HISTORIC AND DESIGN REVIEW COMMISSION

December 21, 2022

HDRC CASE NO: 2022-574
ADDRESS: 145 NAVARRO ST
LEGAL DESCRIPTION: NCB 986 LOT 11 THRU 13 AND E 5.14FT OF 10
ZONING: D, H, RIO-3
CITY COUNCIL DIST.: 1
APPLICANT: Peter Ketter/Sandvick Architects Inc.
OWNER: Kunal Mody/145 NAVARRO LLC
TYPE OF WORK: Construction of a rooftop addition, fenestration modifications, window replacement, rehabilitation, canopy installation and signage
APPLICATION RECEIVED: December 02, 2022
60-DAY REVIEW: Not applicable due to City Council Emergency Orders
CASE MANAGER: Edward Hall
REQUEST:

Proposed Exterior Alterations
HDRC Conceptual Review – December 2022

4 A-1 Existing Window Section
3" = 1'-0"

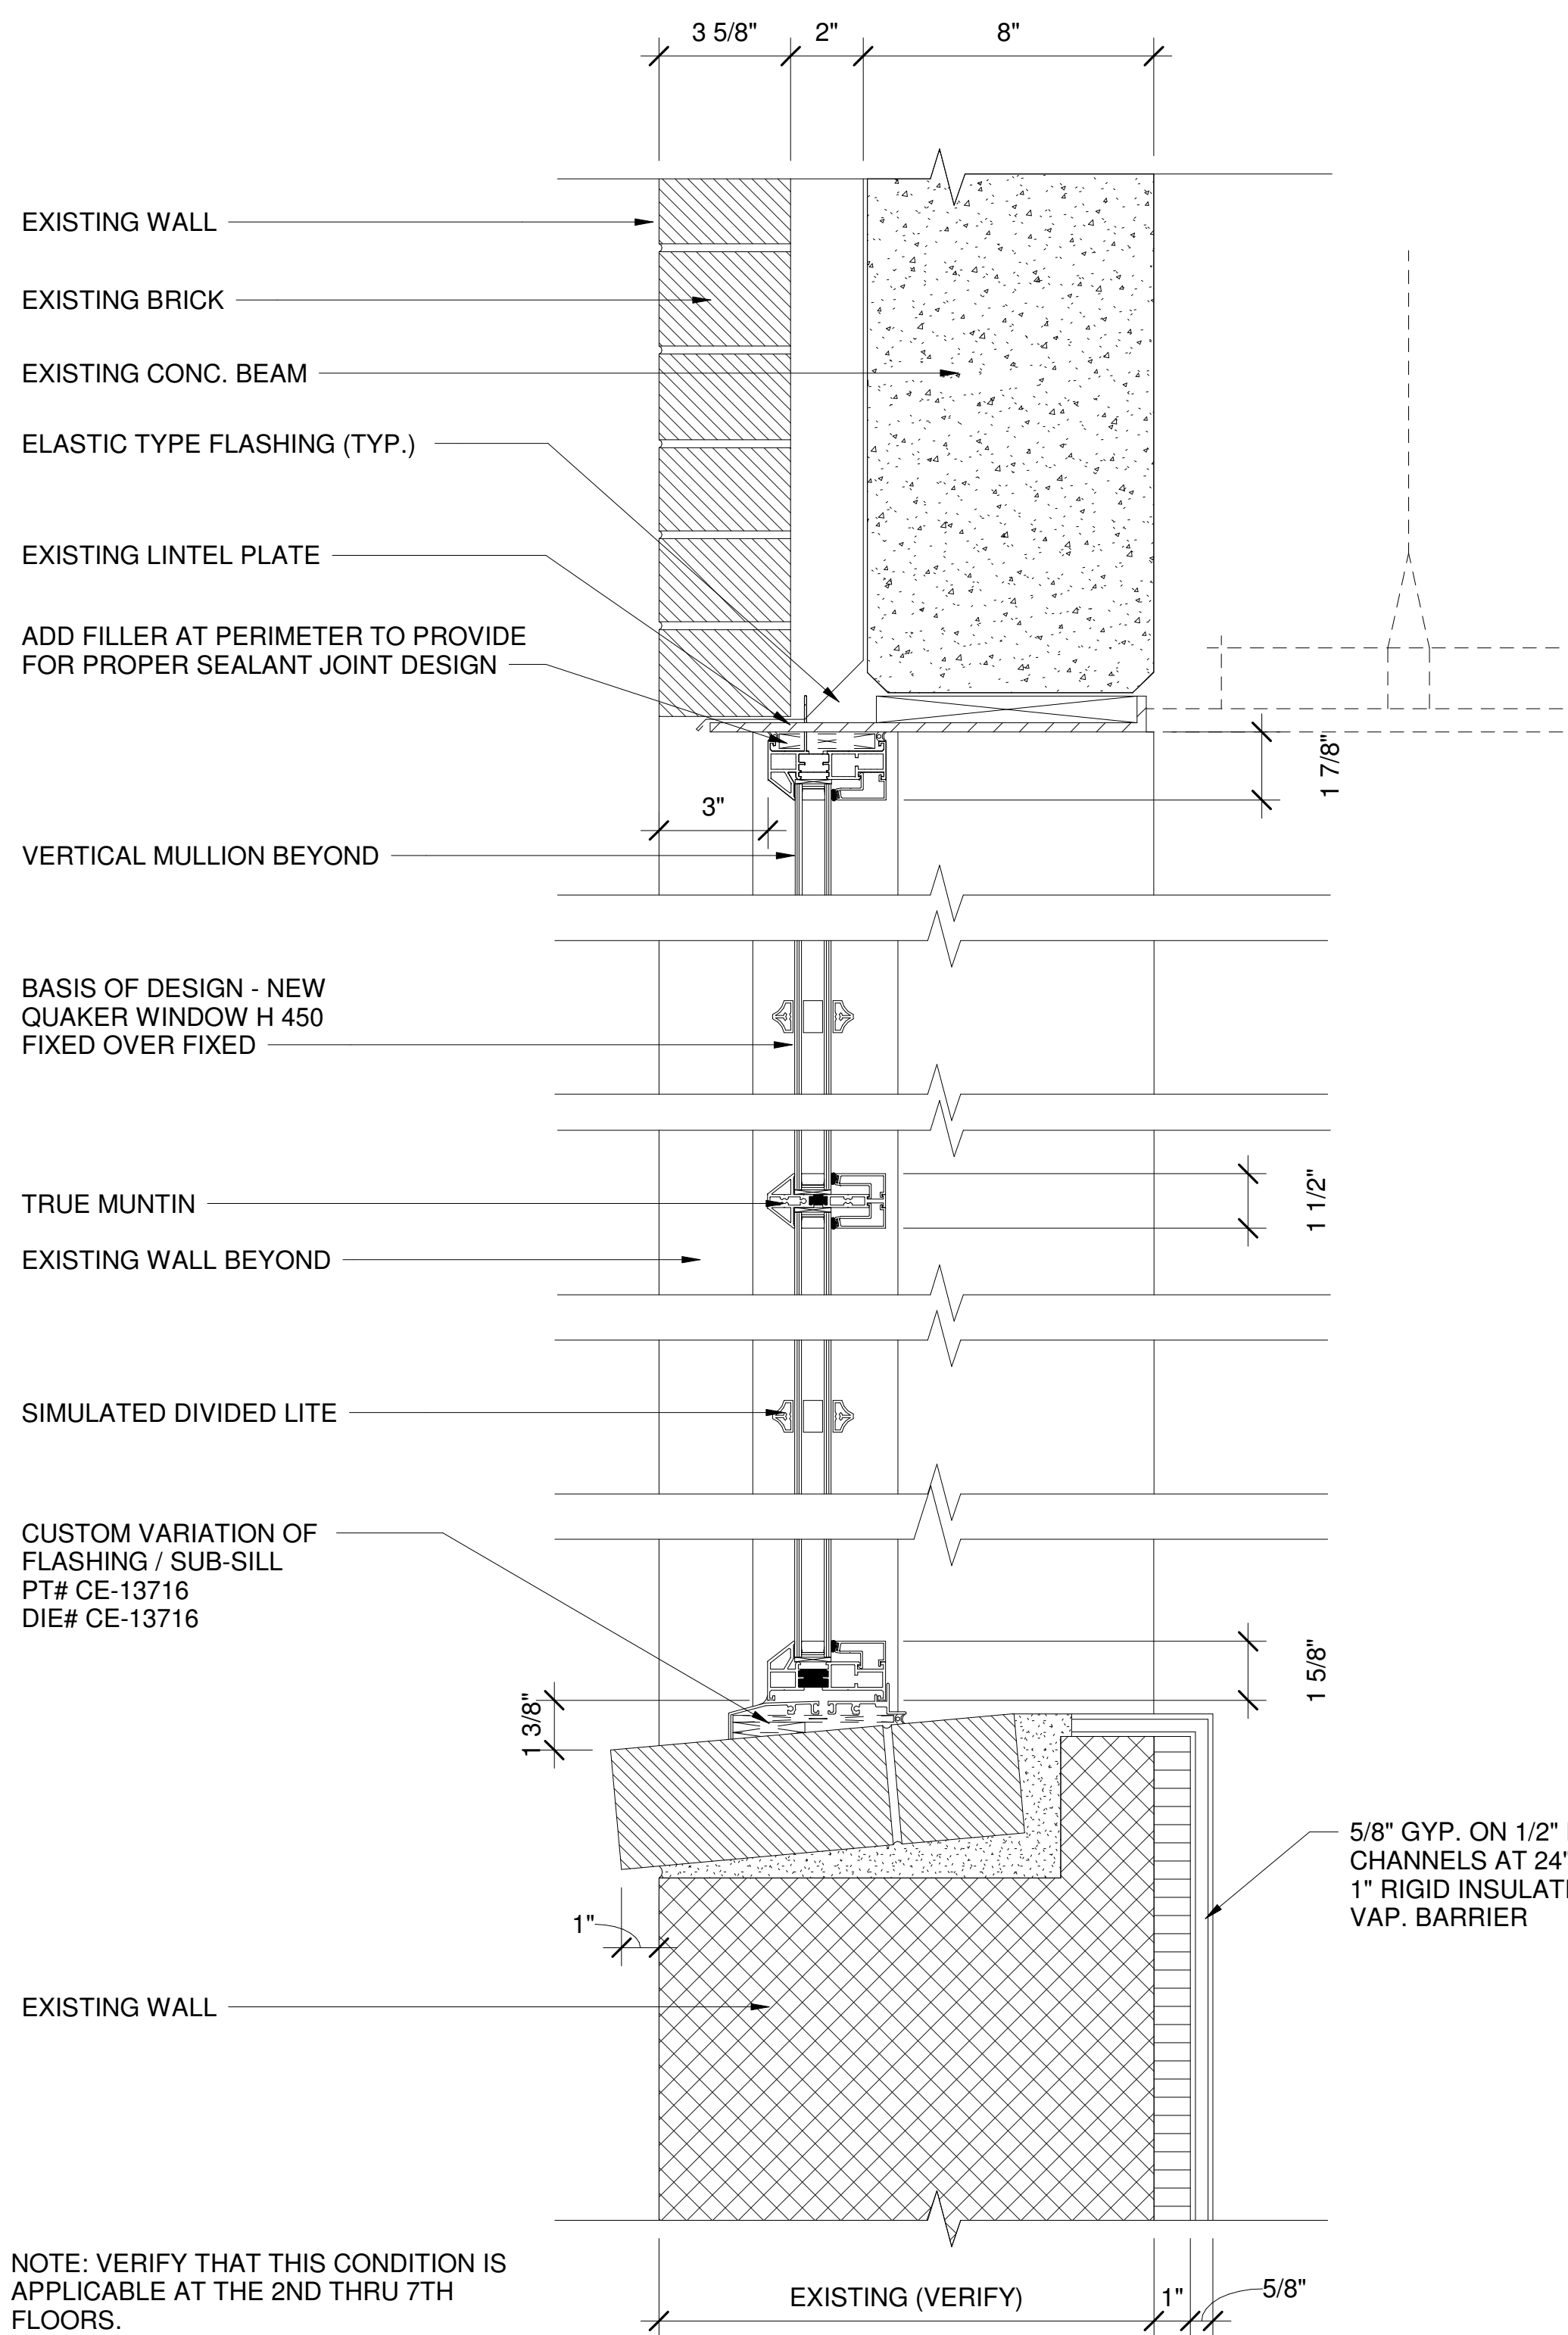
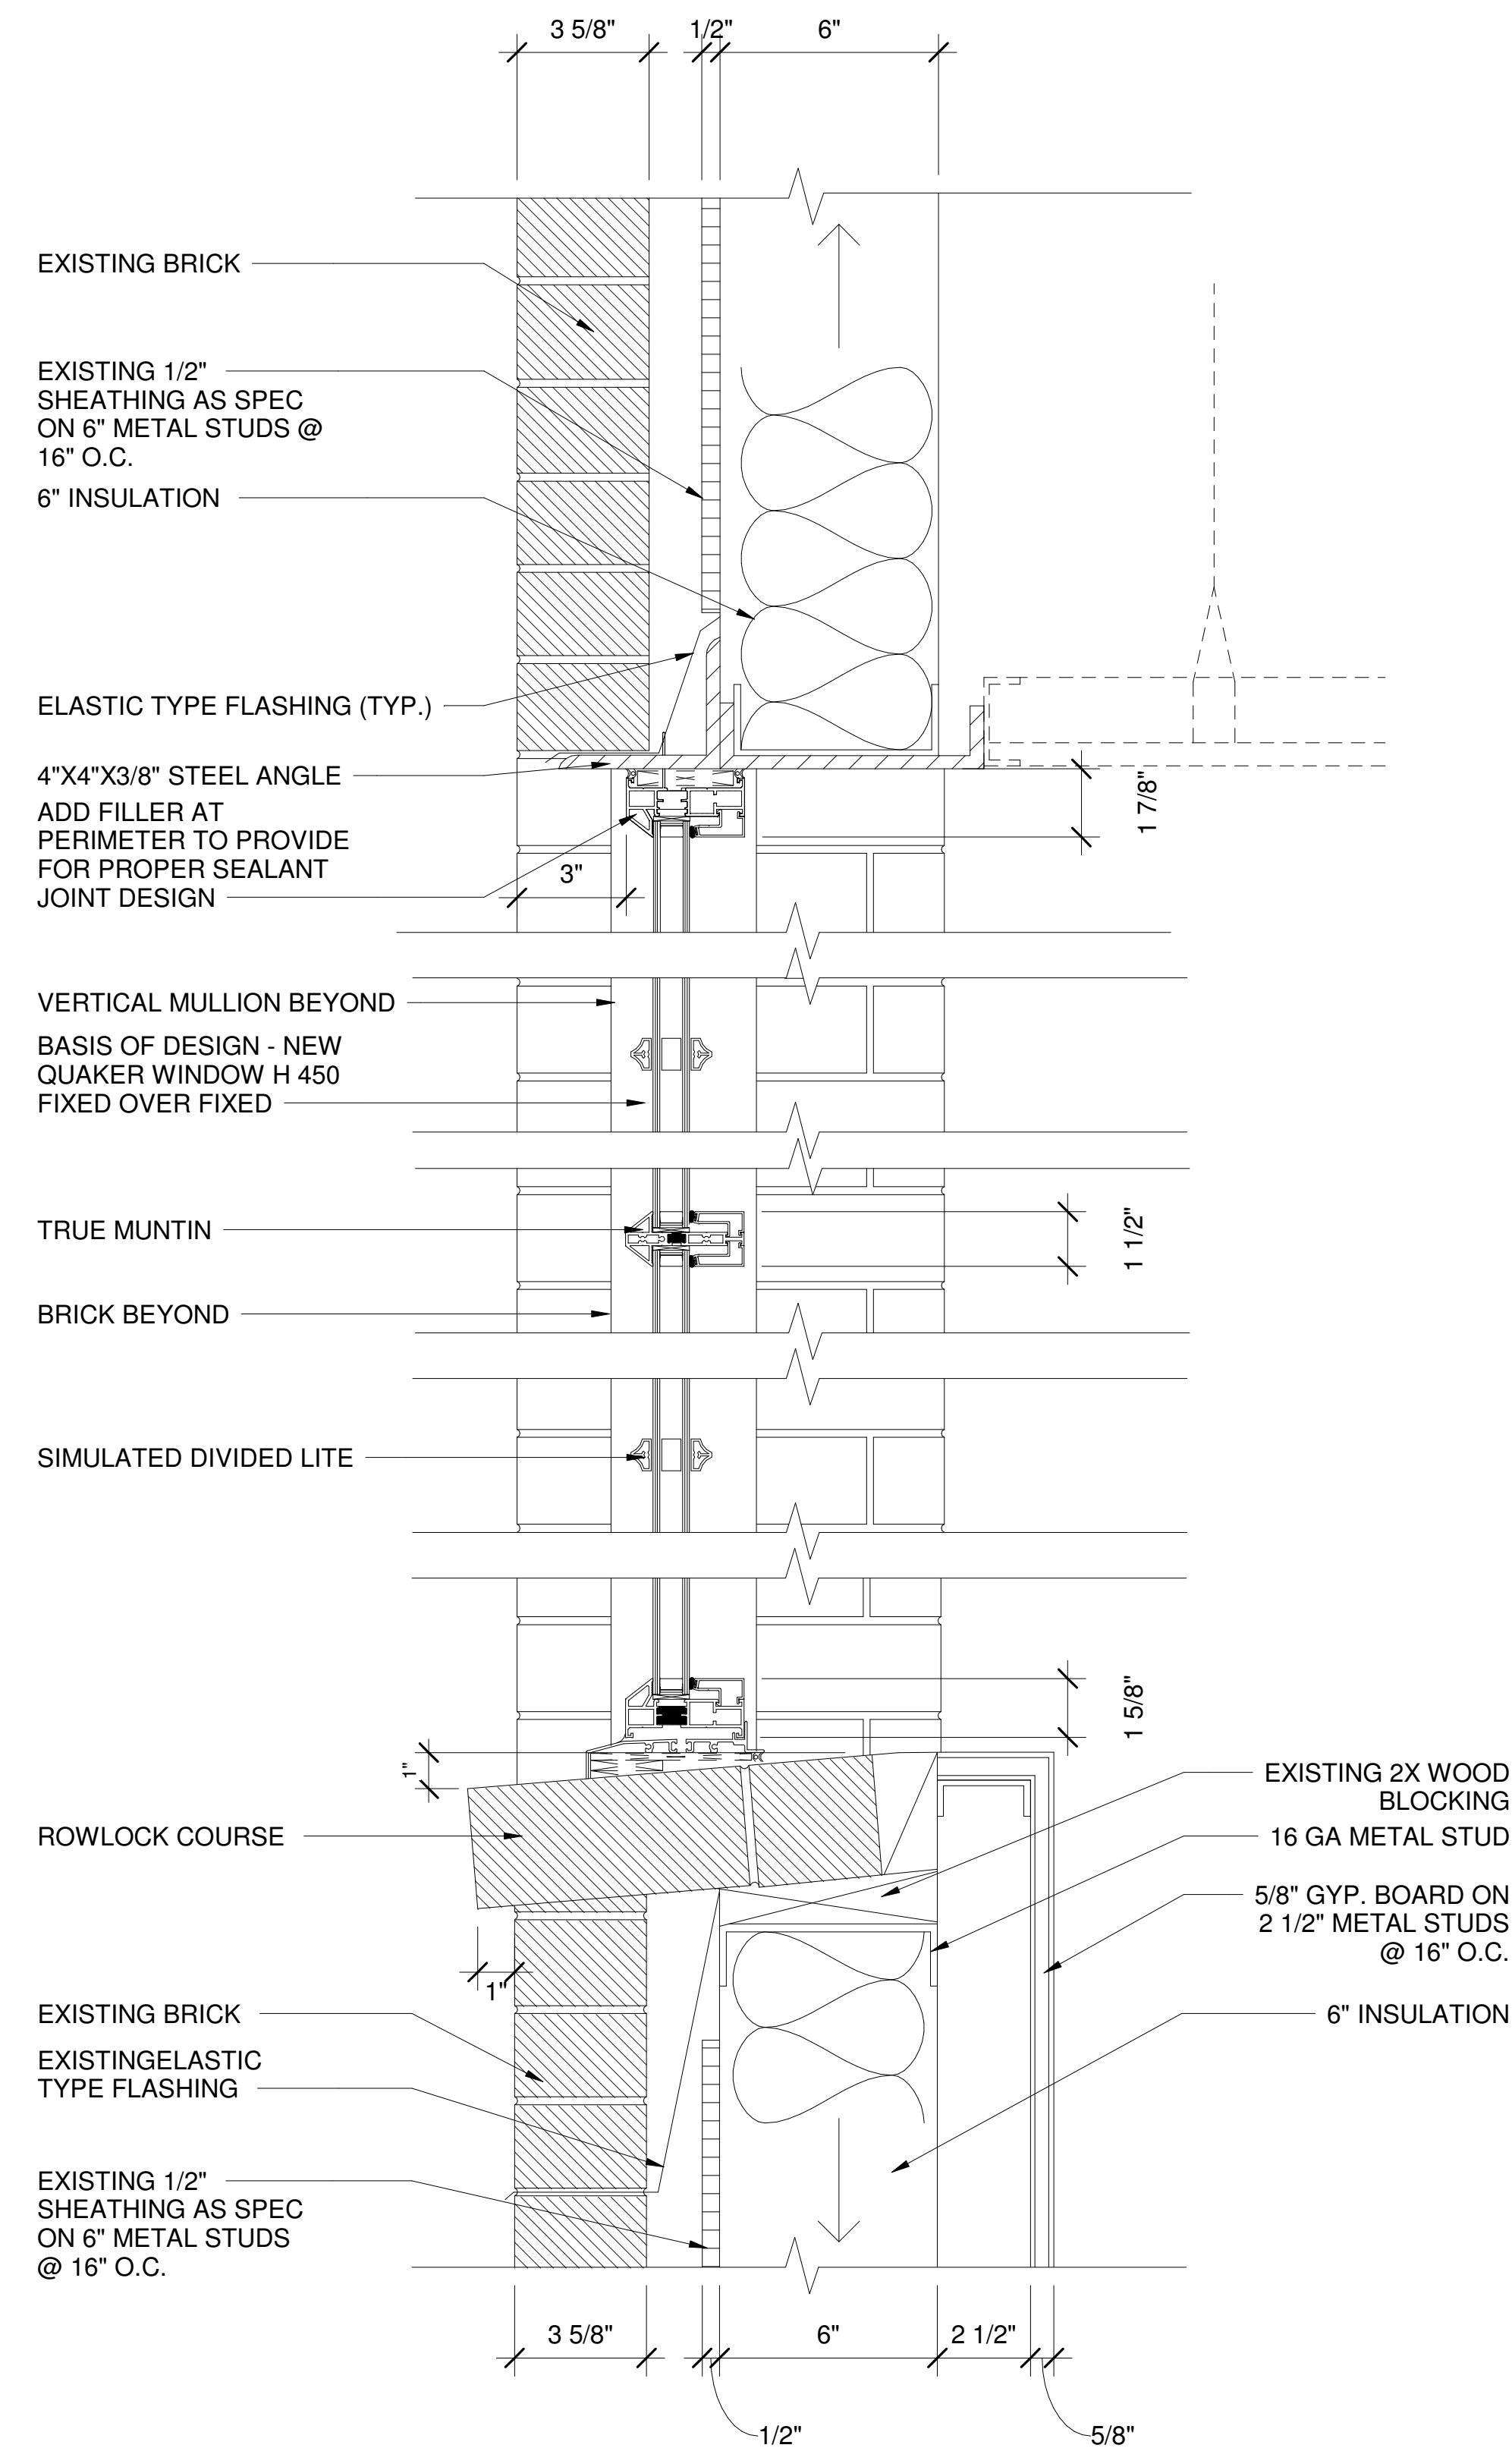
- d. **WINDOW REPLACEMENT** – The applicant has proposed to replace the existing, non-original windows with new, aluminum windows. Historic photos show steel windows featuring a six over six profile. Per historic photos, the original windows were operable. The existing, aluminum windows feature four, single panes. The applicant has proposed aluminum replacement windows that will feature simulated divided lite windows;

however, the proposed simulations will be both internal and external to window panes. The applicant has noted that the proposed windows will also feature true muntins and sloped windows sills. Generally, staff finds the proposed replacement windows to be appropriate; however, staff finds that windows should feature dark colored frames and window components.

- i. That window frames and their components feature dark colors.
3. Staff recommends approval of item #3, storefront system replacement, based on finding e, with the following stipulation:
